CABINET MEMBER FOR ENVIRONMENT - 14 JANUARY 2016

PROPOSED PROHIBITION OF DRIVING AND WAITING RESTRICTION – MEADOW LANE, OXFORD

Report by Deputy Director of Environment & Economy (Commercial)

ANNEX 1

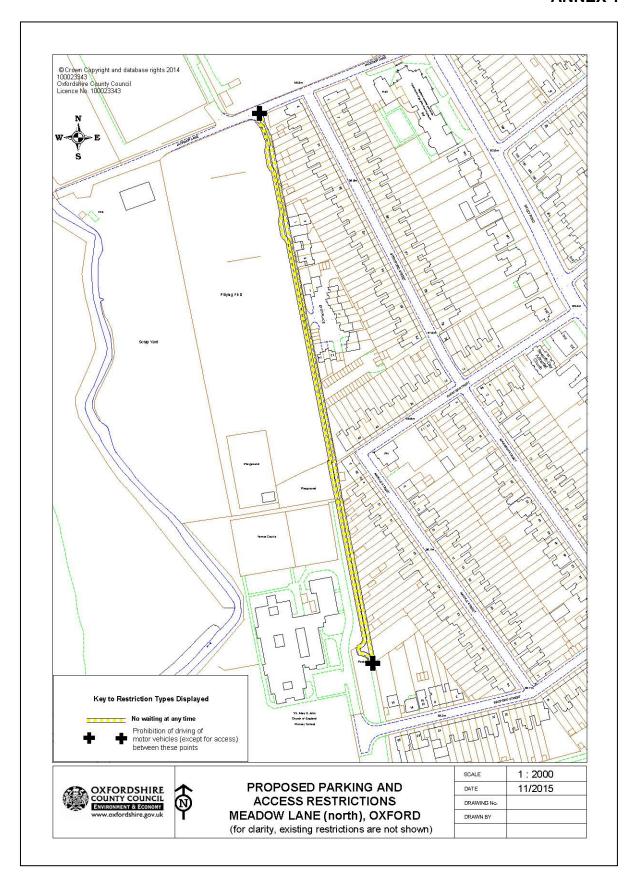
- 5. Thames Valley Police had no objections but sought clarification of the appropriateness of the 'Prohibition of Driving' restriction given the status of Meadow Lane as a public footpath. In response, the intention of this restriction is simply to reinforce the position that even though there will be a prohibition on parking along the road, this does not indicate a general permission for motor vehicles to use the route; it will also allow those who currently use the Lane to access their property to continue to do so.

- 6. Councillor Curran and others expressed concern that the effect of the proposed parking restriction will be to increase parking pressures in nearby residential streets, and that an alternative solution would be for Meadow Lane to be widened on the west side to allow both the current parking to continue and provide additional capacity for other residents to use. In response, the purpose of the restriction is to address current concerns regarding access should the owner of the land on the west side of the Lane choose to widen it to allow parking in the future then the restriction could be amended accordingly.

- 8. Two residents with direct access onto Meadow Lane and another with rear access have objected to the proposals. They suggest that the current practice of parking close to the buildings, or by the playground fence or in the passing bays, does not cause an obstruction. They request that specific provision should be made for residents and visitors (including Blue Badge Holders). In response, whilst it is acknowledged that there are those who do park carefully to avoid causing obstruction, there are others who do not do so and it is considered that the only way to ensure clear access to properties is to remove all parking. Previous proposals for a residents parking scheme in the Iffley Fields area (which included those properties with access onto Meadow Lane) were rejected in 2009 following consultation. With regard to parking for Blue Badge holders, this is permitted on double yellow lines for up to 3 hours providing no obstruction occurs.
